SUBJECT: Responds to NRC 930901 ltr re violations noted in Insp Rept 50-305/93-12. Corrective actions: USAR will be revised to reflect how control room post-accident recirculation sys described in EOP E-ACC-25.

Docket 50-305
Operating License DPR-43
Kewaunee Nuclear Power Plant
Response to Notice of Violation 93-012-01

Reference: Letter from L.R. Greger (NRC) to C.A. Schrock (WPSC) dated September 1, 1993 (Inspection Report 93-012)

Re: Inspection Report 93-012

CONTROL ROOM AIR CONDITIONING

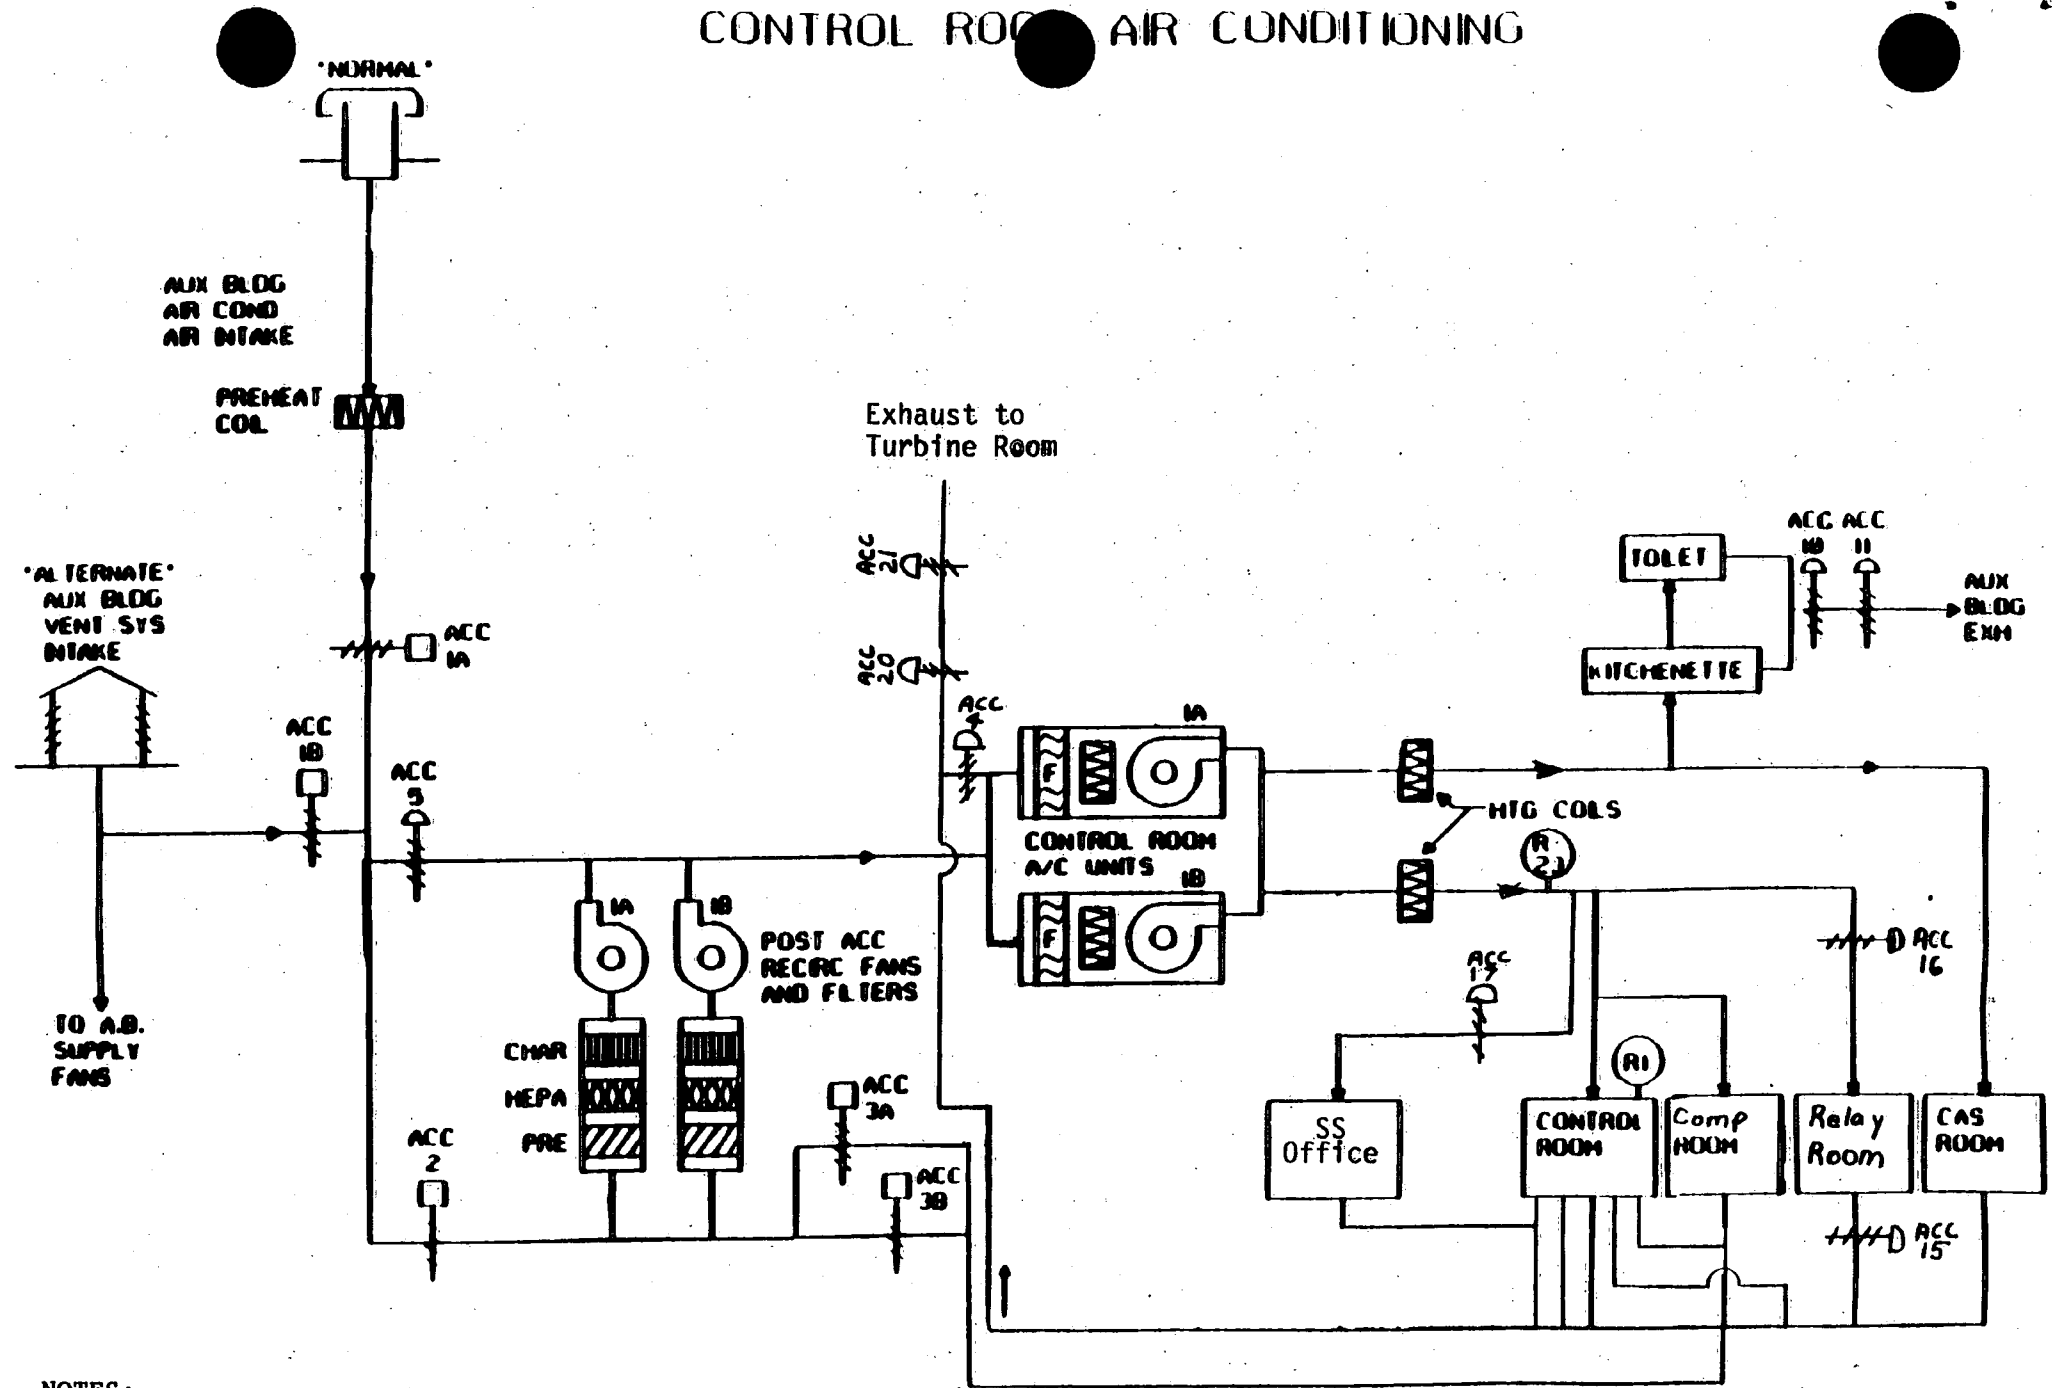
Contrary to the above, Safety Evaluation Report, Revision 0, dated March 8, 1991, for DCR 2373-2, "Control Room Post-Accident Recirculation Dampers ACC-3A & ACC-3B and Fresh Inlet Damper ACC-2," did not identify that the change created the possibility of a different type of malfunction than previously evaluated in the safety analysis report, did not adequately determine if the change involved an unreviewed safety question, and consequently did not provide an adequate bases for the determination that the change did not involve an unreviewed safety question. (305/93012-01)

Design Change Request (DCR) 2373-2 was implemented in April 1991 to remove the interlock between the fresh air inlet damper (ACC-2) and the redundant recirculation dampers (ACC-3A and ACC-3B) in the control room post-accident recirculation (CRPR) system, refer to attachment 2. Removal of the interlock prevents a single failure of ACC-2 from isolating recirculation flow through ACC-3A or ACC-3B. As noted in the inspection report, the design package for the DCR failed to provide adequate justification that the removal of the interlock did not increase the probability of bypassing the charcoal filters. Bypassing the filters would allow unfiltered contaminated air to enter the control room.

In addition to the corrective actions already taken, the USAR will be revised to reflect how the system is described in operating procedure E-ACC-25. The annual update to the USAR is currently scheduled to be submitted to the NRC in November 1994. Furthermore, DCR 2373-2 will be used as a case study in the refresher training on the performance of safety evaluations. The training is tentatively scheduled to occur during the first quarter of 1994. The training will be provided to members of the engineering staff that are typically responsible for performing safety evaluations.
